**ADDENDUM No. 1**

**Lincoln and Adams Elementary Schools 2024 Kitchen Upgrades**

Arch. Project #220117

## ADDENDUM NO. 1

**A2.1**

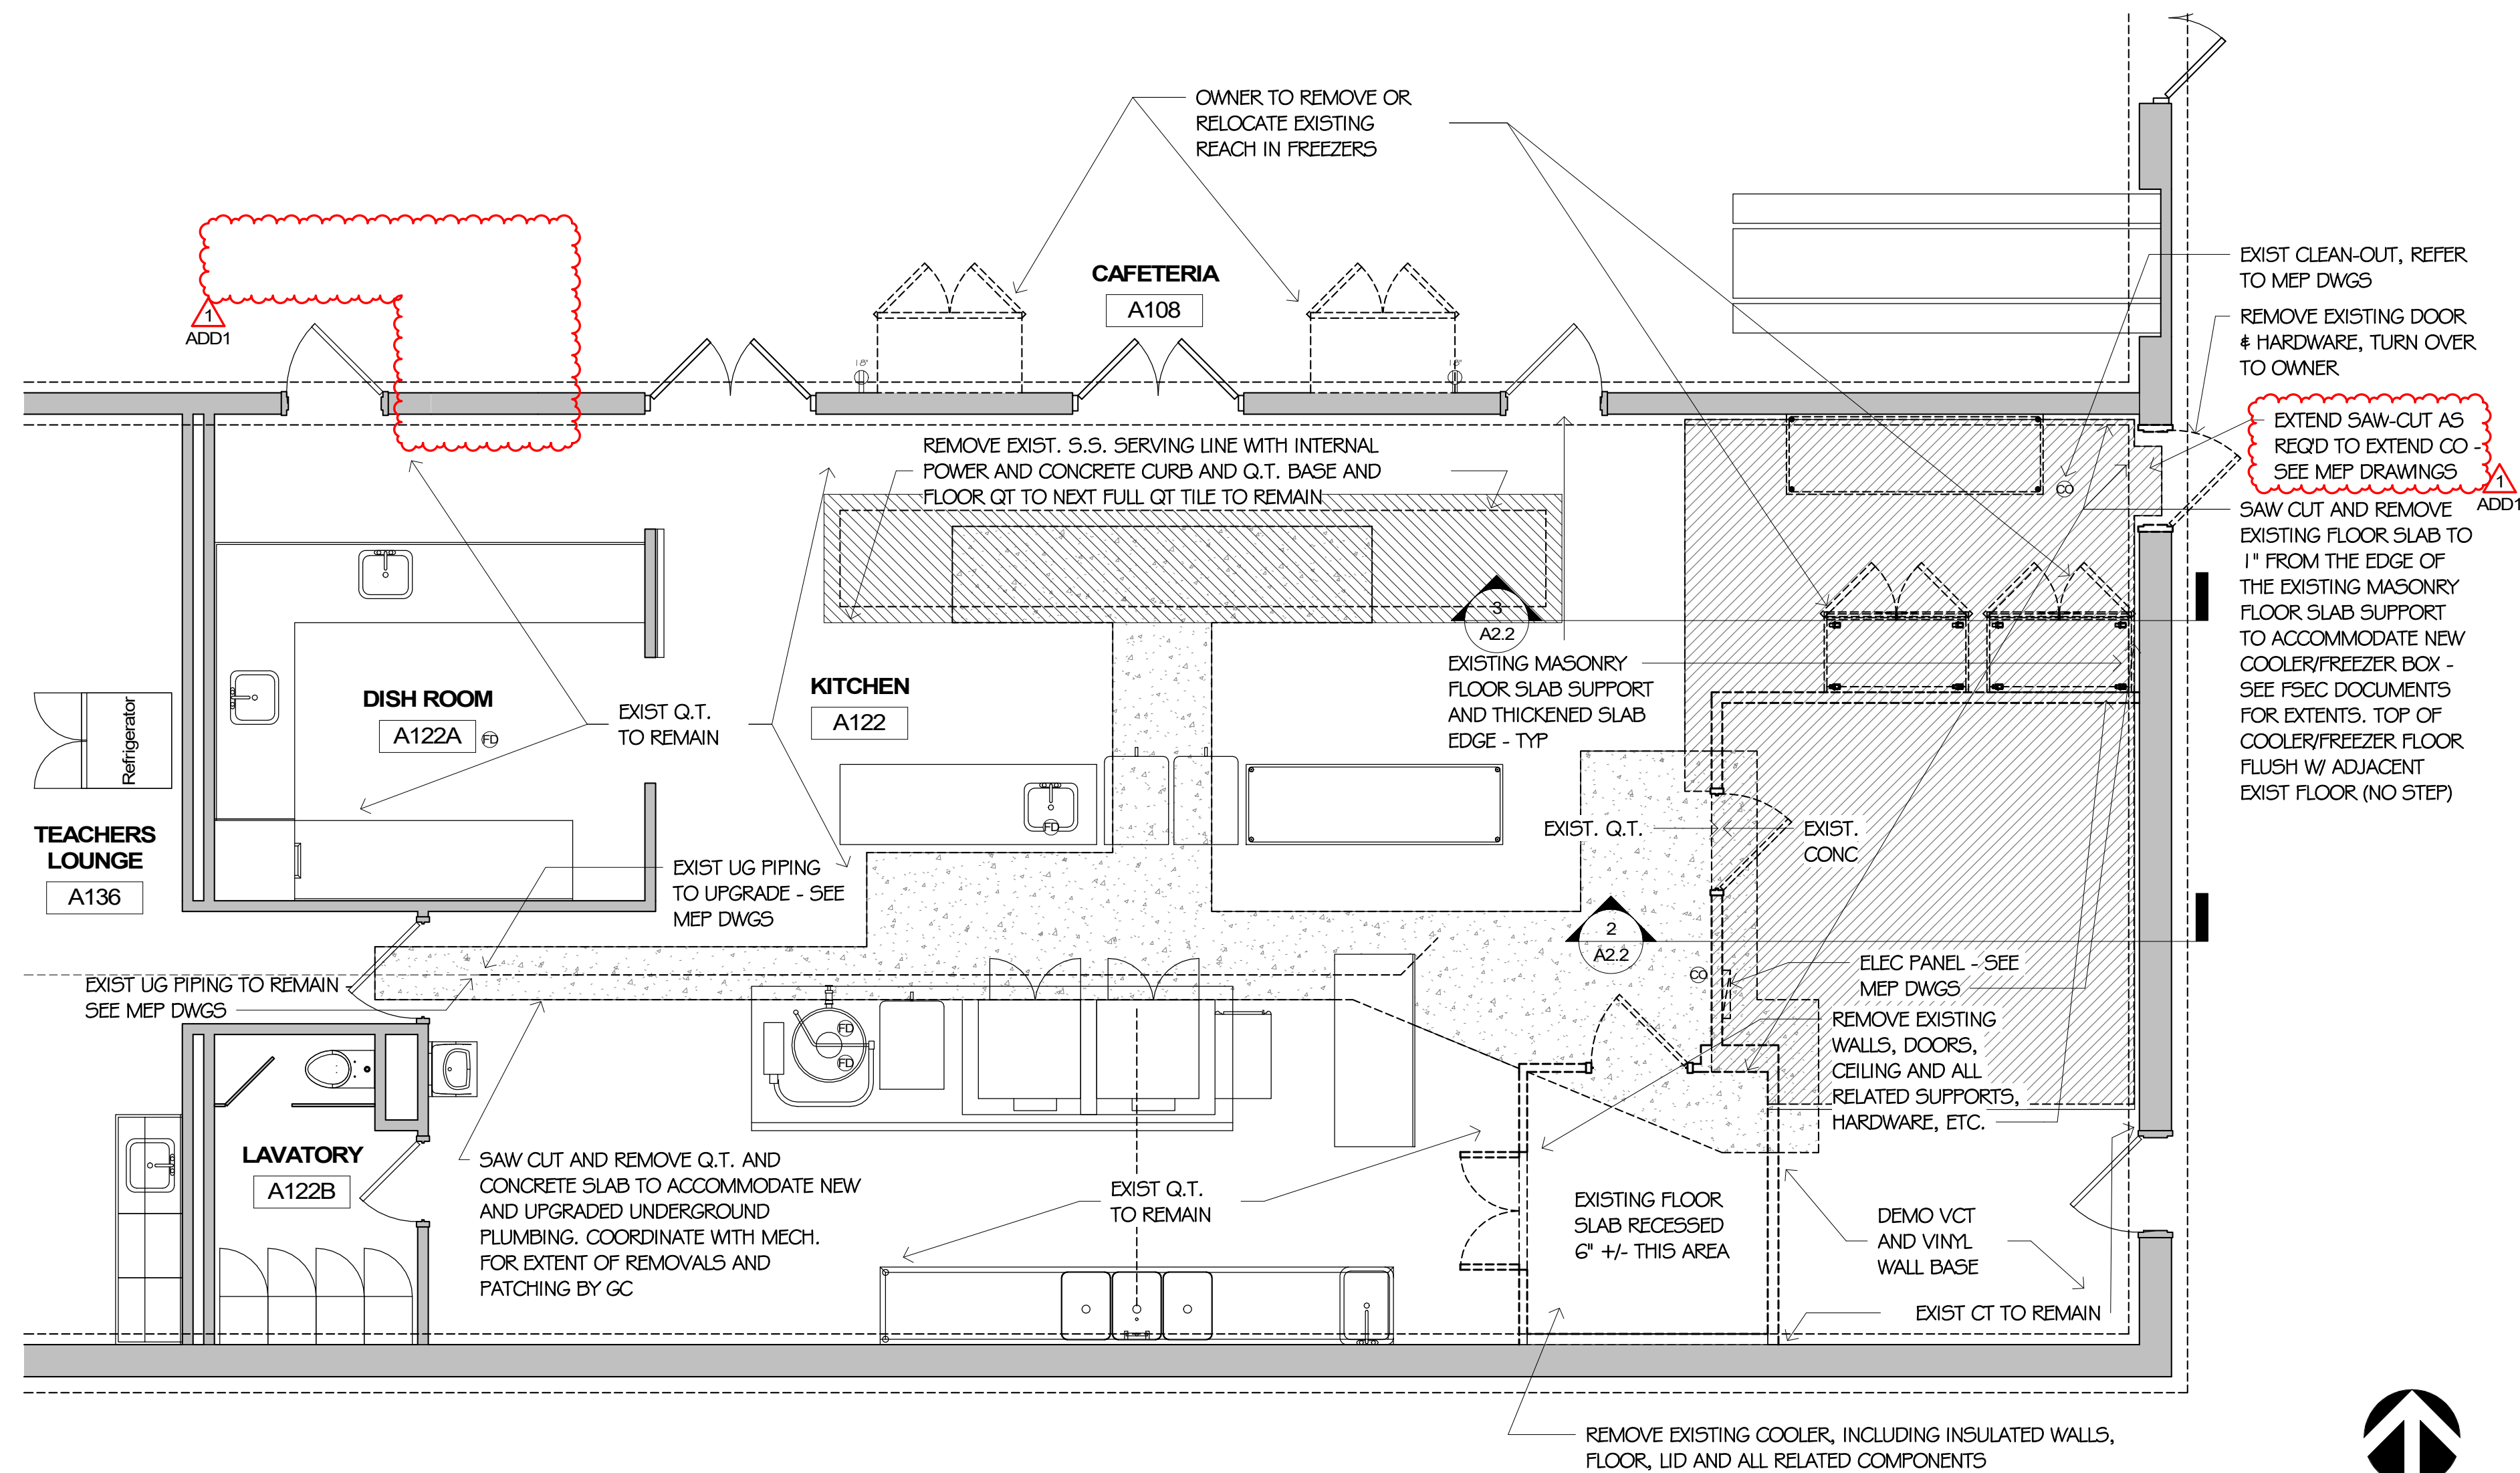
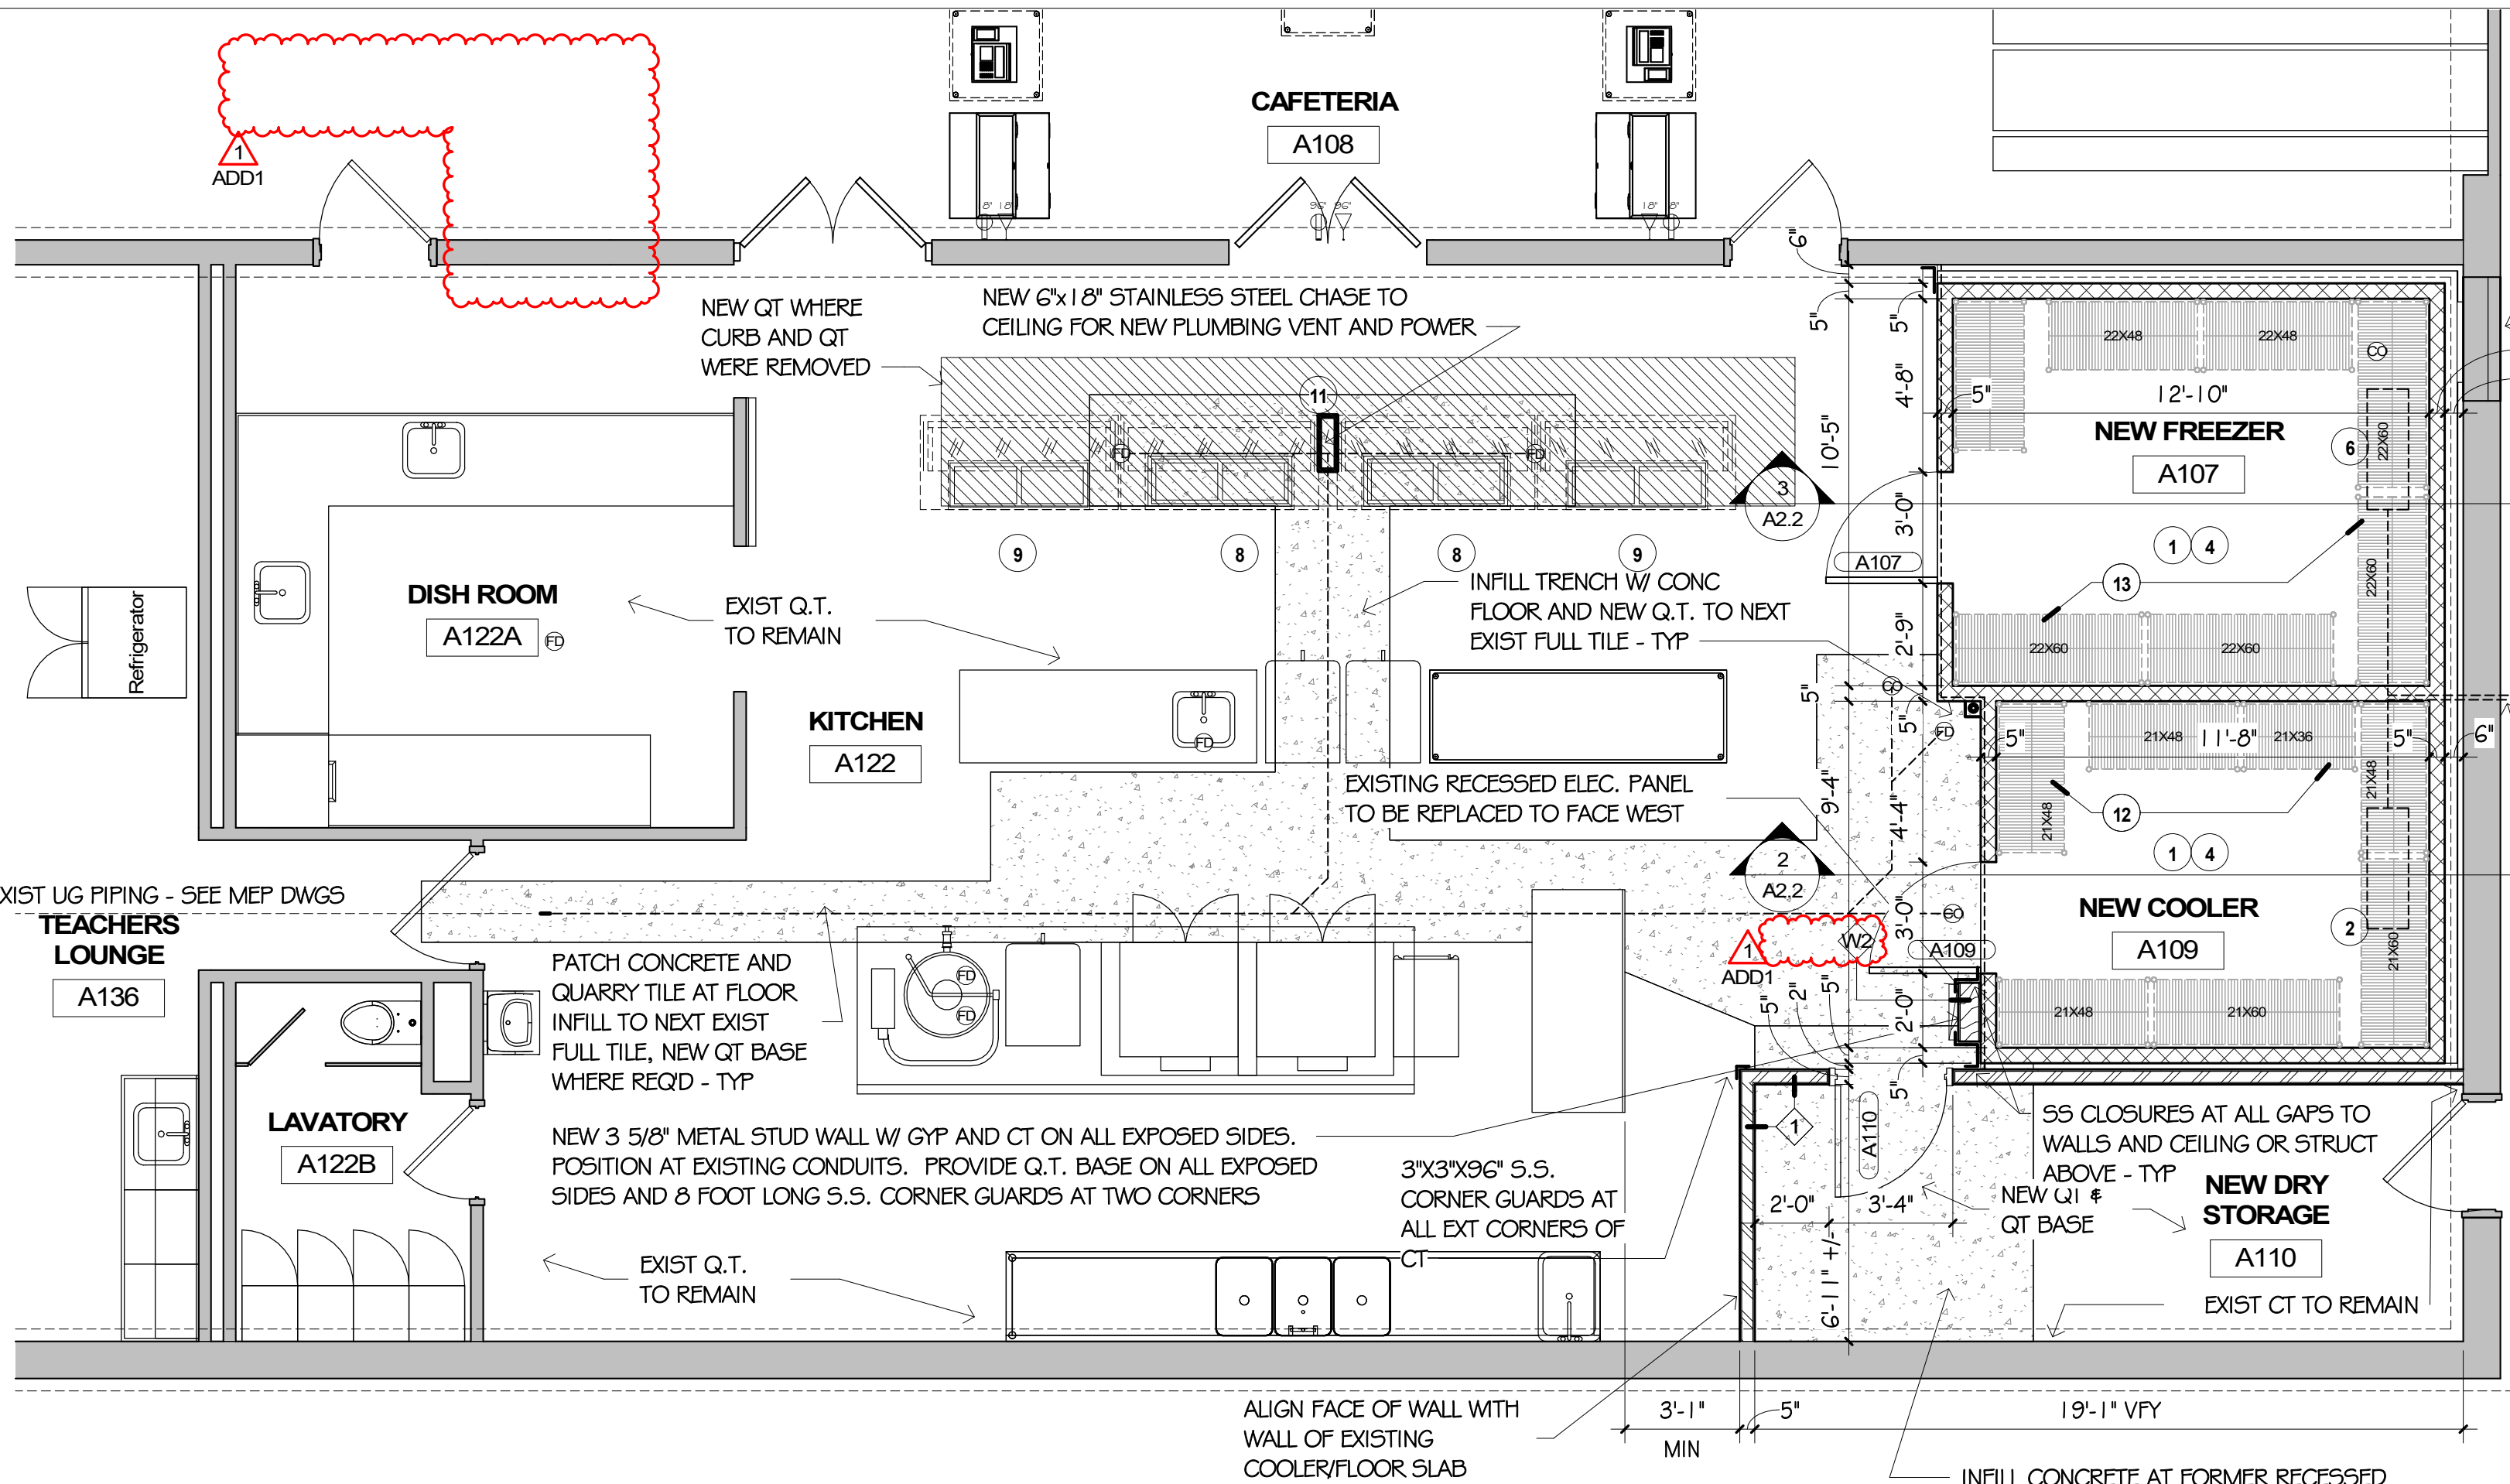
**Item 5 Sheet A2.1:**

- a. Omit reference to the new opening in the wall north of Room A122A.
- b. Extend saw-cut into existing door opening to extend cleanout to new wall cleanout.

A2.2

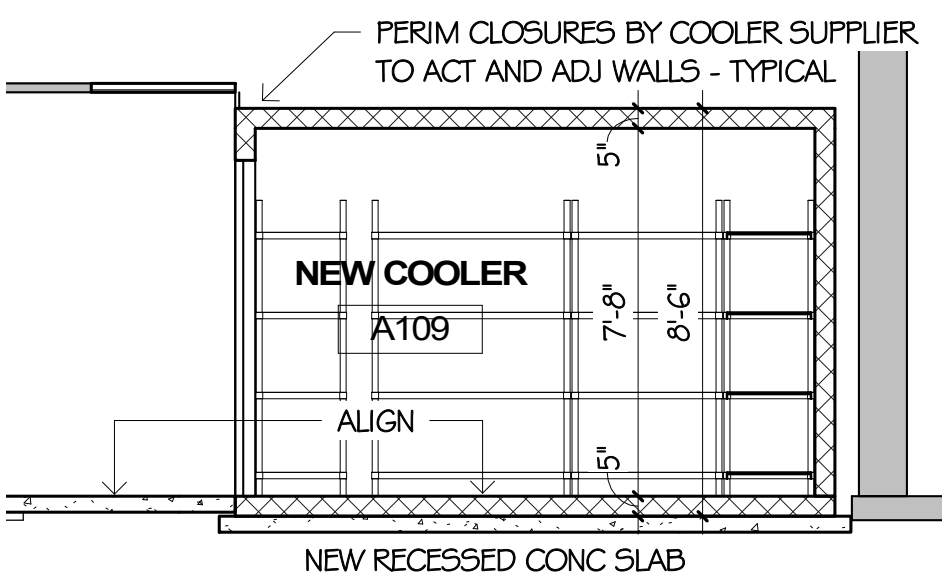
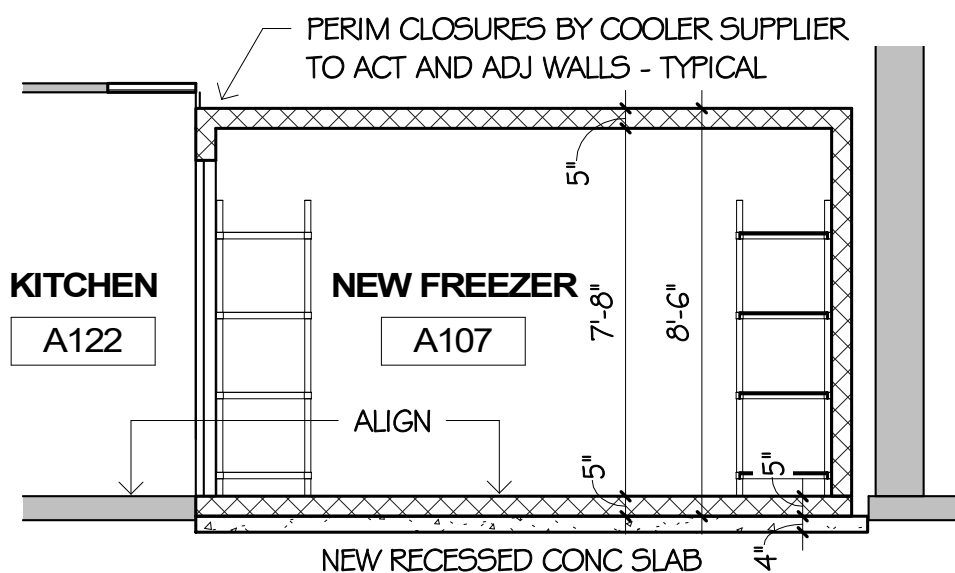
**Item 6 Sheet A2.2:**

- c. Revise the new metal stud wall adjacent to Door A109 to have 6" studs rather than 3 5/8" studs as indicated. (Wall type 2).
- d. Delete Door A122E from the Floor Plan and Opening Schedule and notes.

- e. Add the following note: The Contractor shall provide a total of six (6) 4" diameter core drilled holes above the ceilings along the condenser line route from the new cooler/freezer to the condenser location in the boiler room. It is to be assumed that four of the new holes are through one-hour fire rated walls and shall be filled to meet applicable codes regarding penetrations in fire rated walls.

- f. Add the following note to the existing hallway: FSEC to remove existing acoustic tile ceiling as needed and run line sets above existing hallway ceiling from the new cooler/freezer coils to the refrigeration units to be located in the boiler room. Work is to be coordinated with existing conditions and may require additional turns and/or length of material to accommodate existing pipes, ducts, etc. FSEC to reinstall ceiling to match existing conditions.

- g. Add the following note to boiler room: "NOTE: AT NEW ROOF PENETRATIONS AND/OR MECH CURBS (REFER TO MEP DRAWINGS) EXISTING ROOF IS A SBS MODIFIED BITUMEN ROOFING SYSTEM -OWNER'S ROOFING CONSULTANT WILL PROVIDE FINAL ROOF CURB FLASHING ONTO TO

CURB/CANTS/BLOCKING BY CONTRACTOR, AND MAKE THE TIE-IN TO EXISTING ROOFING”

h. Add floor and wall finish patch to RFS note C.

1. Section 114000-A1.3.k Add: Three (3) 3" x 3" x 96" 16 gauge stainless steel corner guards as shown on sheet A2.2 at electrical panel and exterior corner of New Dry Storage Room A110.
2. Sheet A2.2 Redline Note for installation of refrigeration line from walk-in cooler/freezer to condensers that are to be located in Mechanical Room.

FSEC TO REMOVE EXISTING ACOUSTIC TILE CEILING AS NEEDED AND RUN LINE SETS ABOVE EXISTING HALLWAY CEILING FROM THE NEW COOLER/FREEZER COILS TO THE REFRIGERATION UNITS TO BE LOCATED IN THE BOILER ROOM. WORK IS TO BE COORDINATED WITH EXISTING CONDITIONS AND MAY REQUIRE ADDITIONAL TURNS AND/OR LENGTH OF MATERIAL TO ACCOMMODATE EXISTING PIPES, DUCTS, ETC. FSEC TO REINSTALL CEILING TO MATCH EXISTING CONDITIONS

THE CONTRACTOR SHALL PROVIDE A TOTAL OF SIX (6) 4" DIAMETER CORE DRILLED HOLES ABOVE THE CEILINGS ALONG THE CONDENSER LINE ROUTE FROM THE NEW COOLER/FREEZER TO THE CONDENSER LOCATION IN THE BOILER ROOM. IT IS TO BE ASSUMED THAT FOUR OF THE NEW HOLES ARE THROUGH ONE-HOUR FIRE RATED WALLS AND SHALL BE FILLED TO MEET APPLICABLE CODES REGARDING PENETRATIONS IN FIRE RATED WALLS

NOTE: AT NEW ROOF PENETRATIONS AND/OR MECH CURBS (REFER TO MEP DRAWINGS) EXISTING ROOF IS A SBS MODIFIED BITUMEN ROOFING SYSTEM - OWNER'S ROOFING CONSULTANT WILL PROVIDE FINAL ROOF CURB FLASHING ONTO TO CURB/CANTS/BLOCKING BY CONTRACTOR, AND MAKE THE TIE-IN TO EXISTING ROOFING

## A2.3

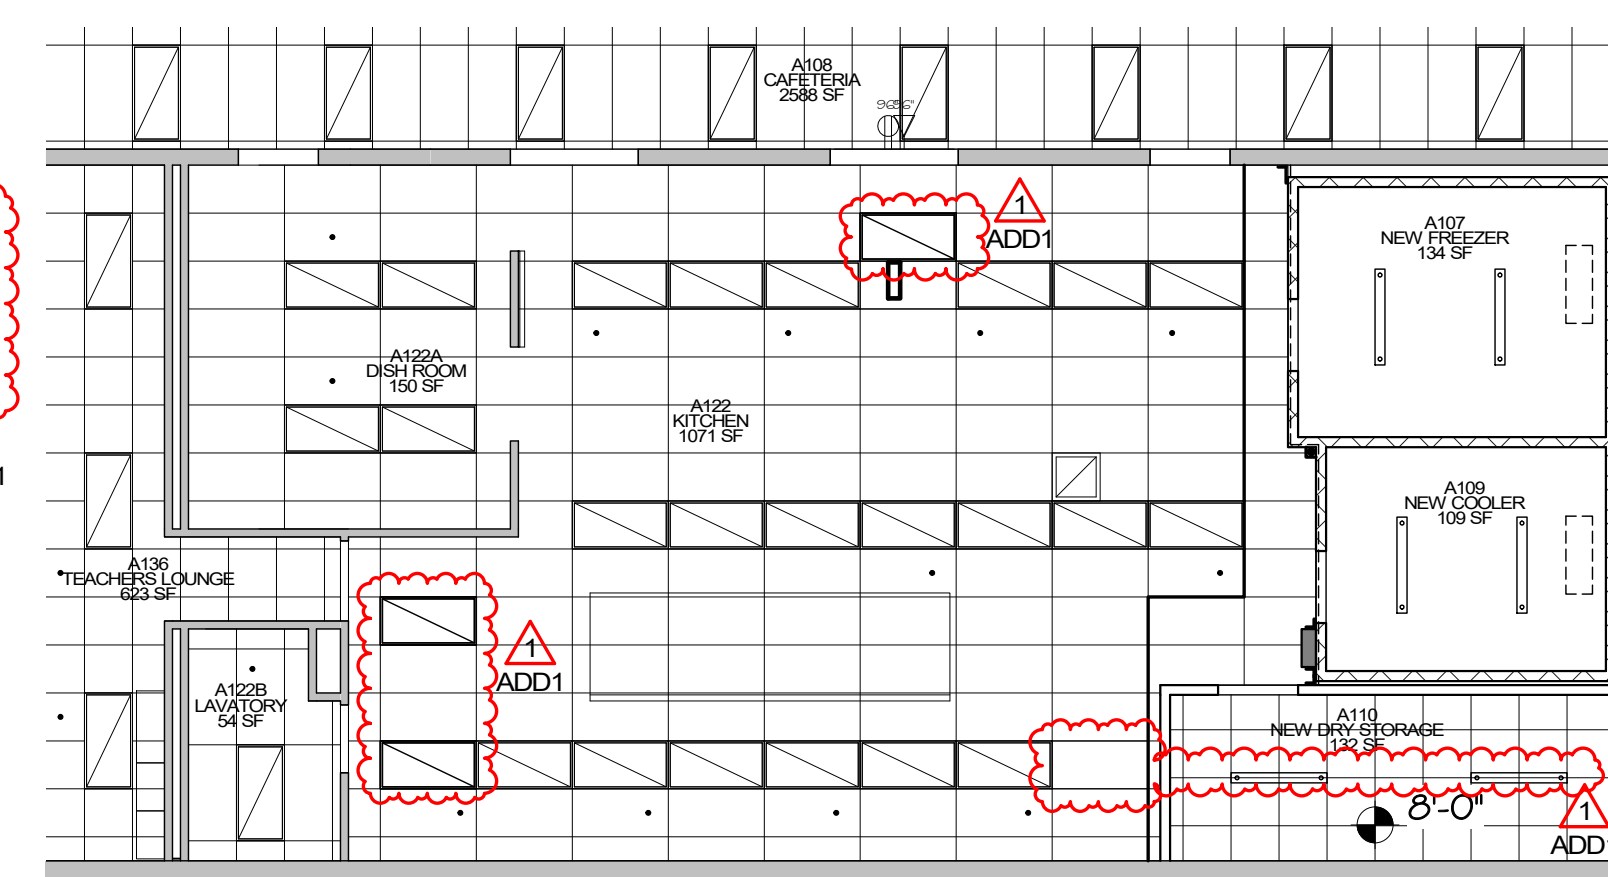
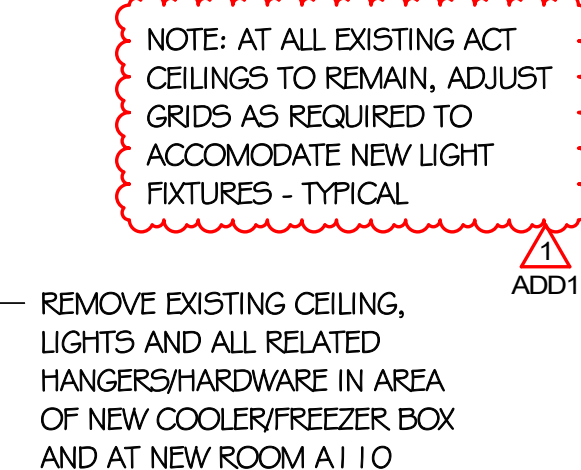
**Item 7 Sheet A2.3:** Add note to adjust existing ACT grids as required for new lighting layout. Existing and New lighting updated to match MEP drawings.
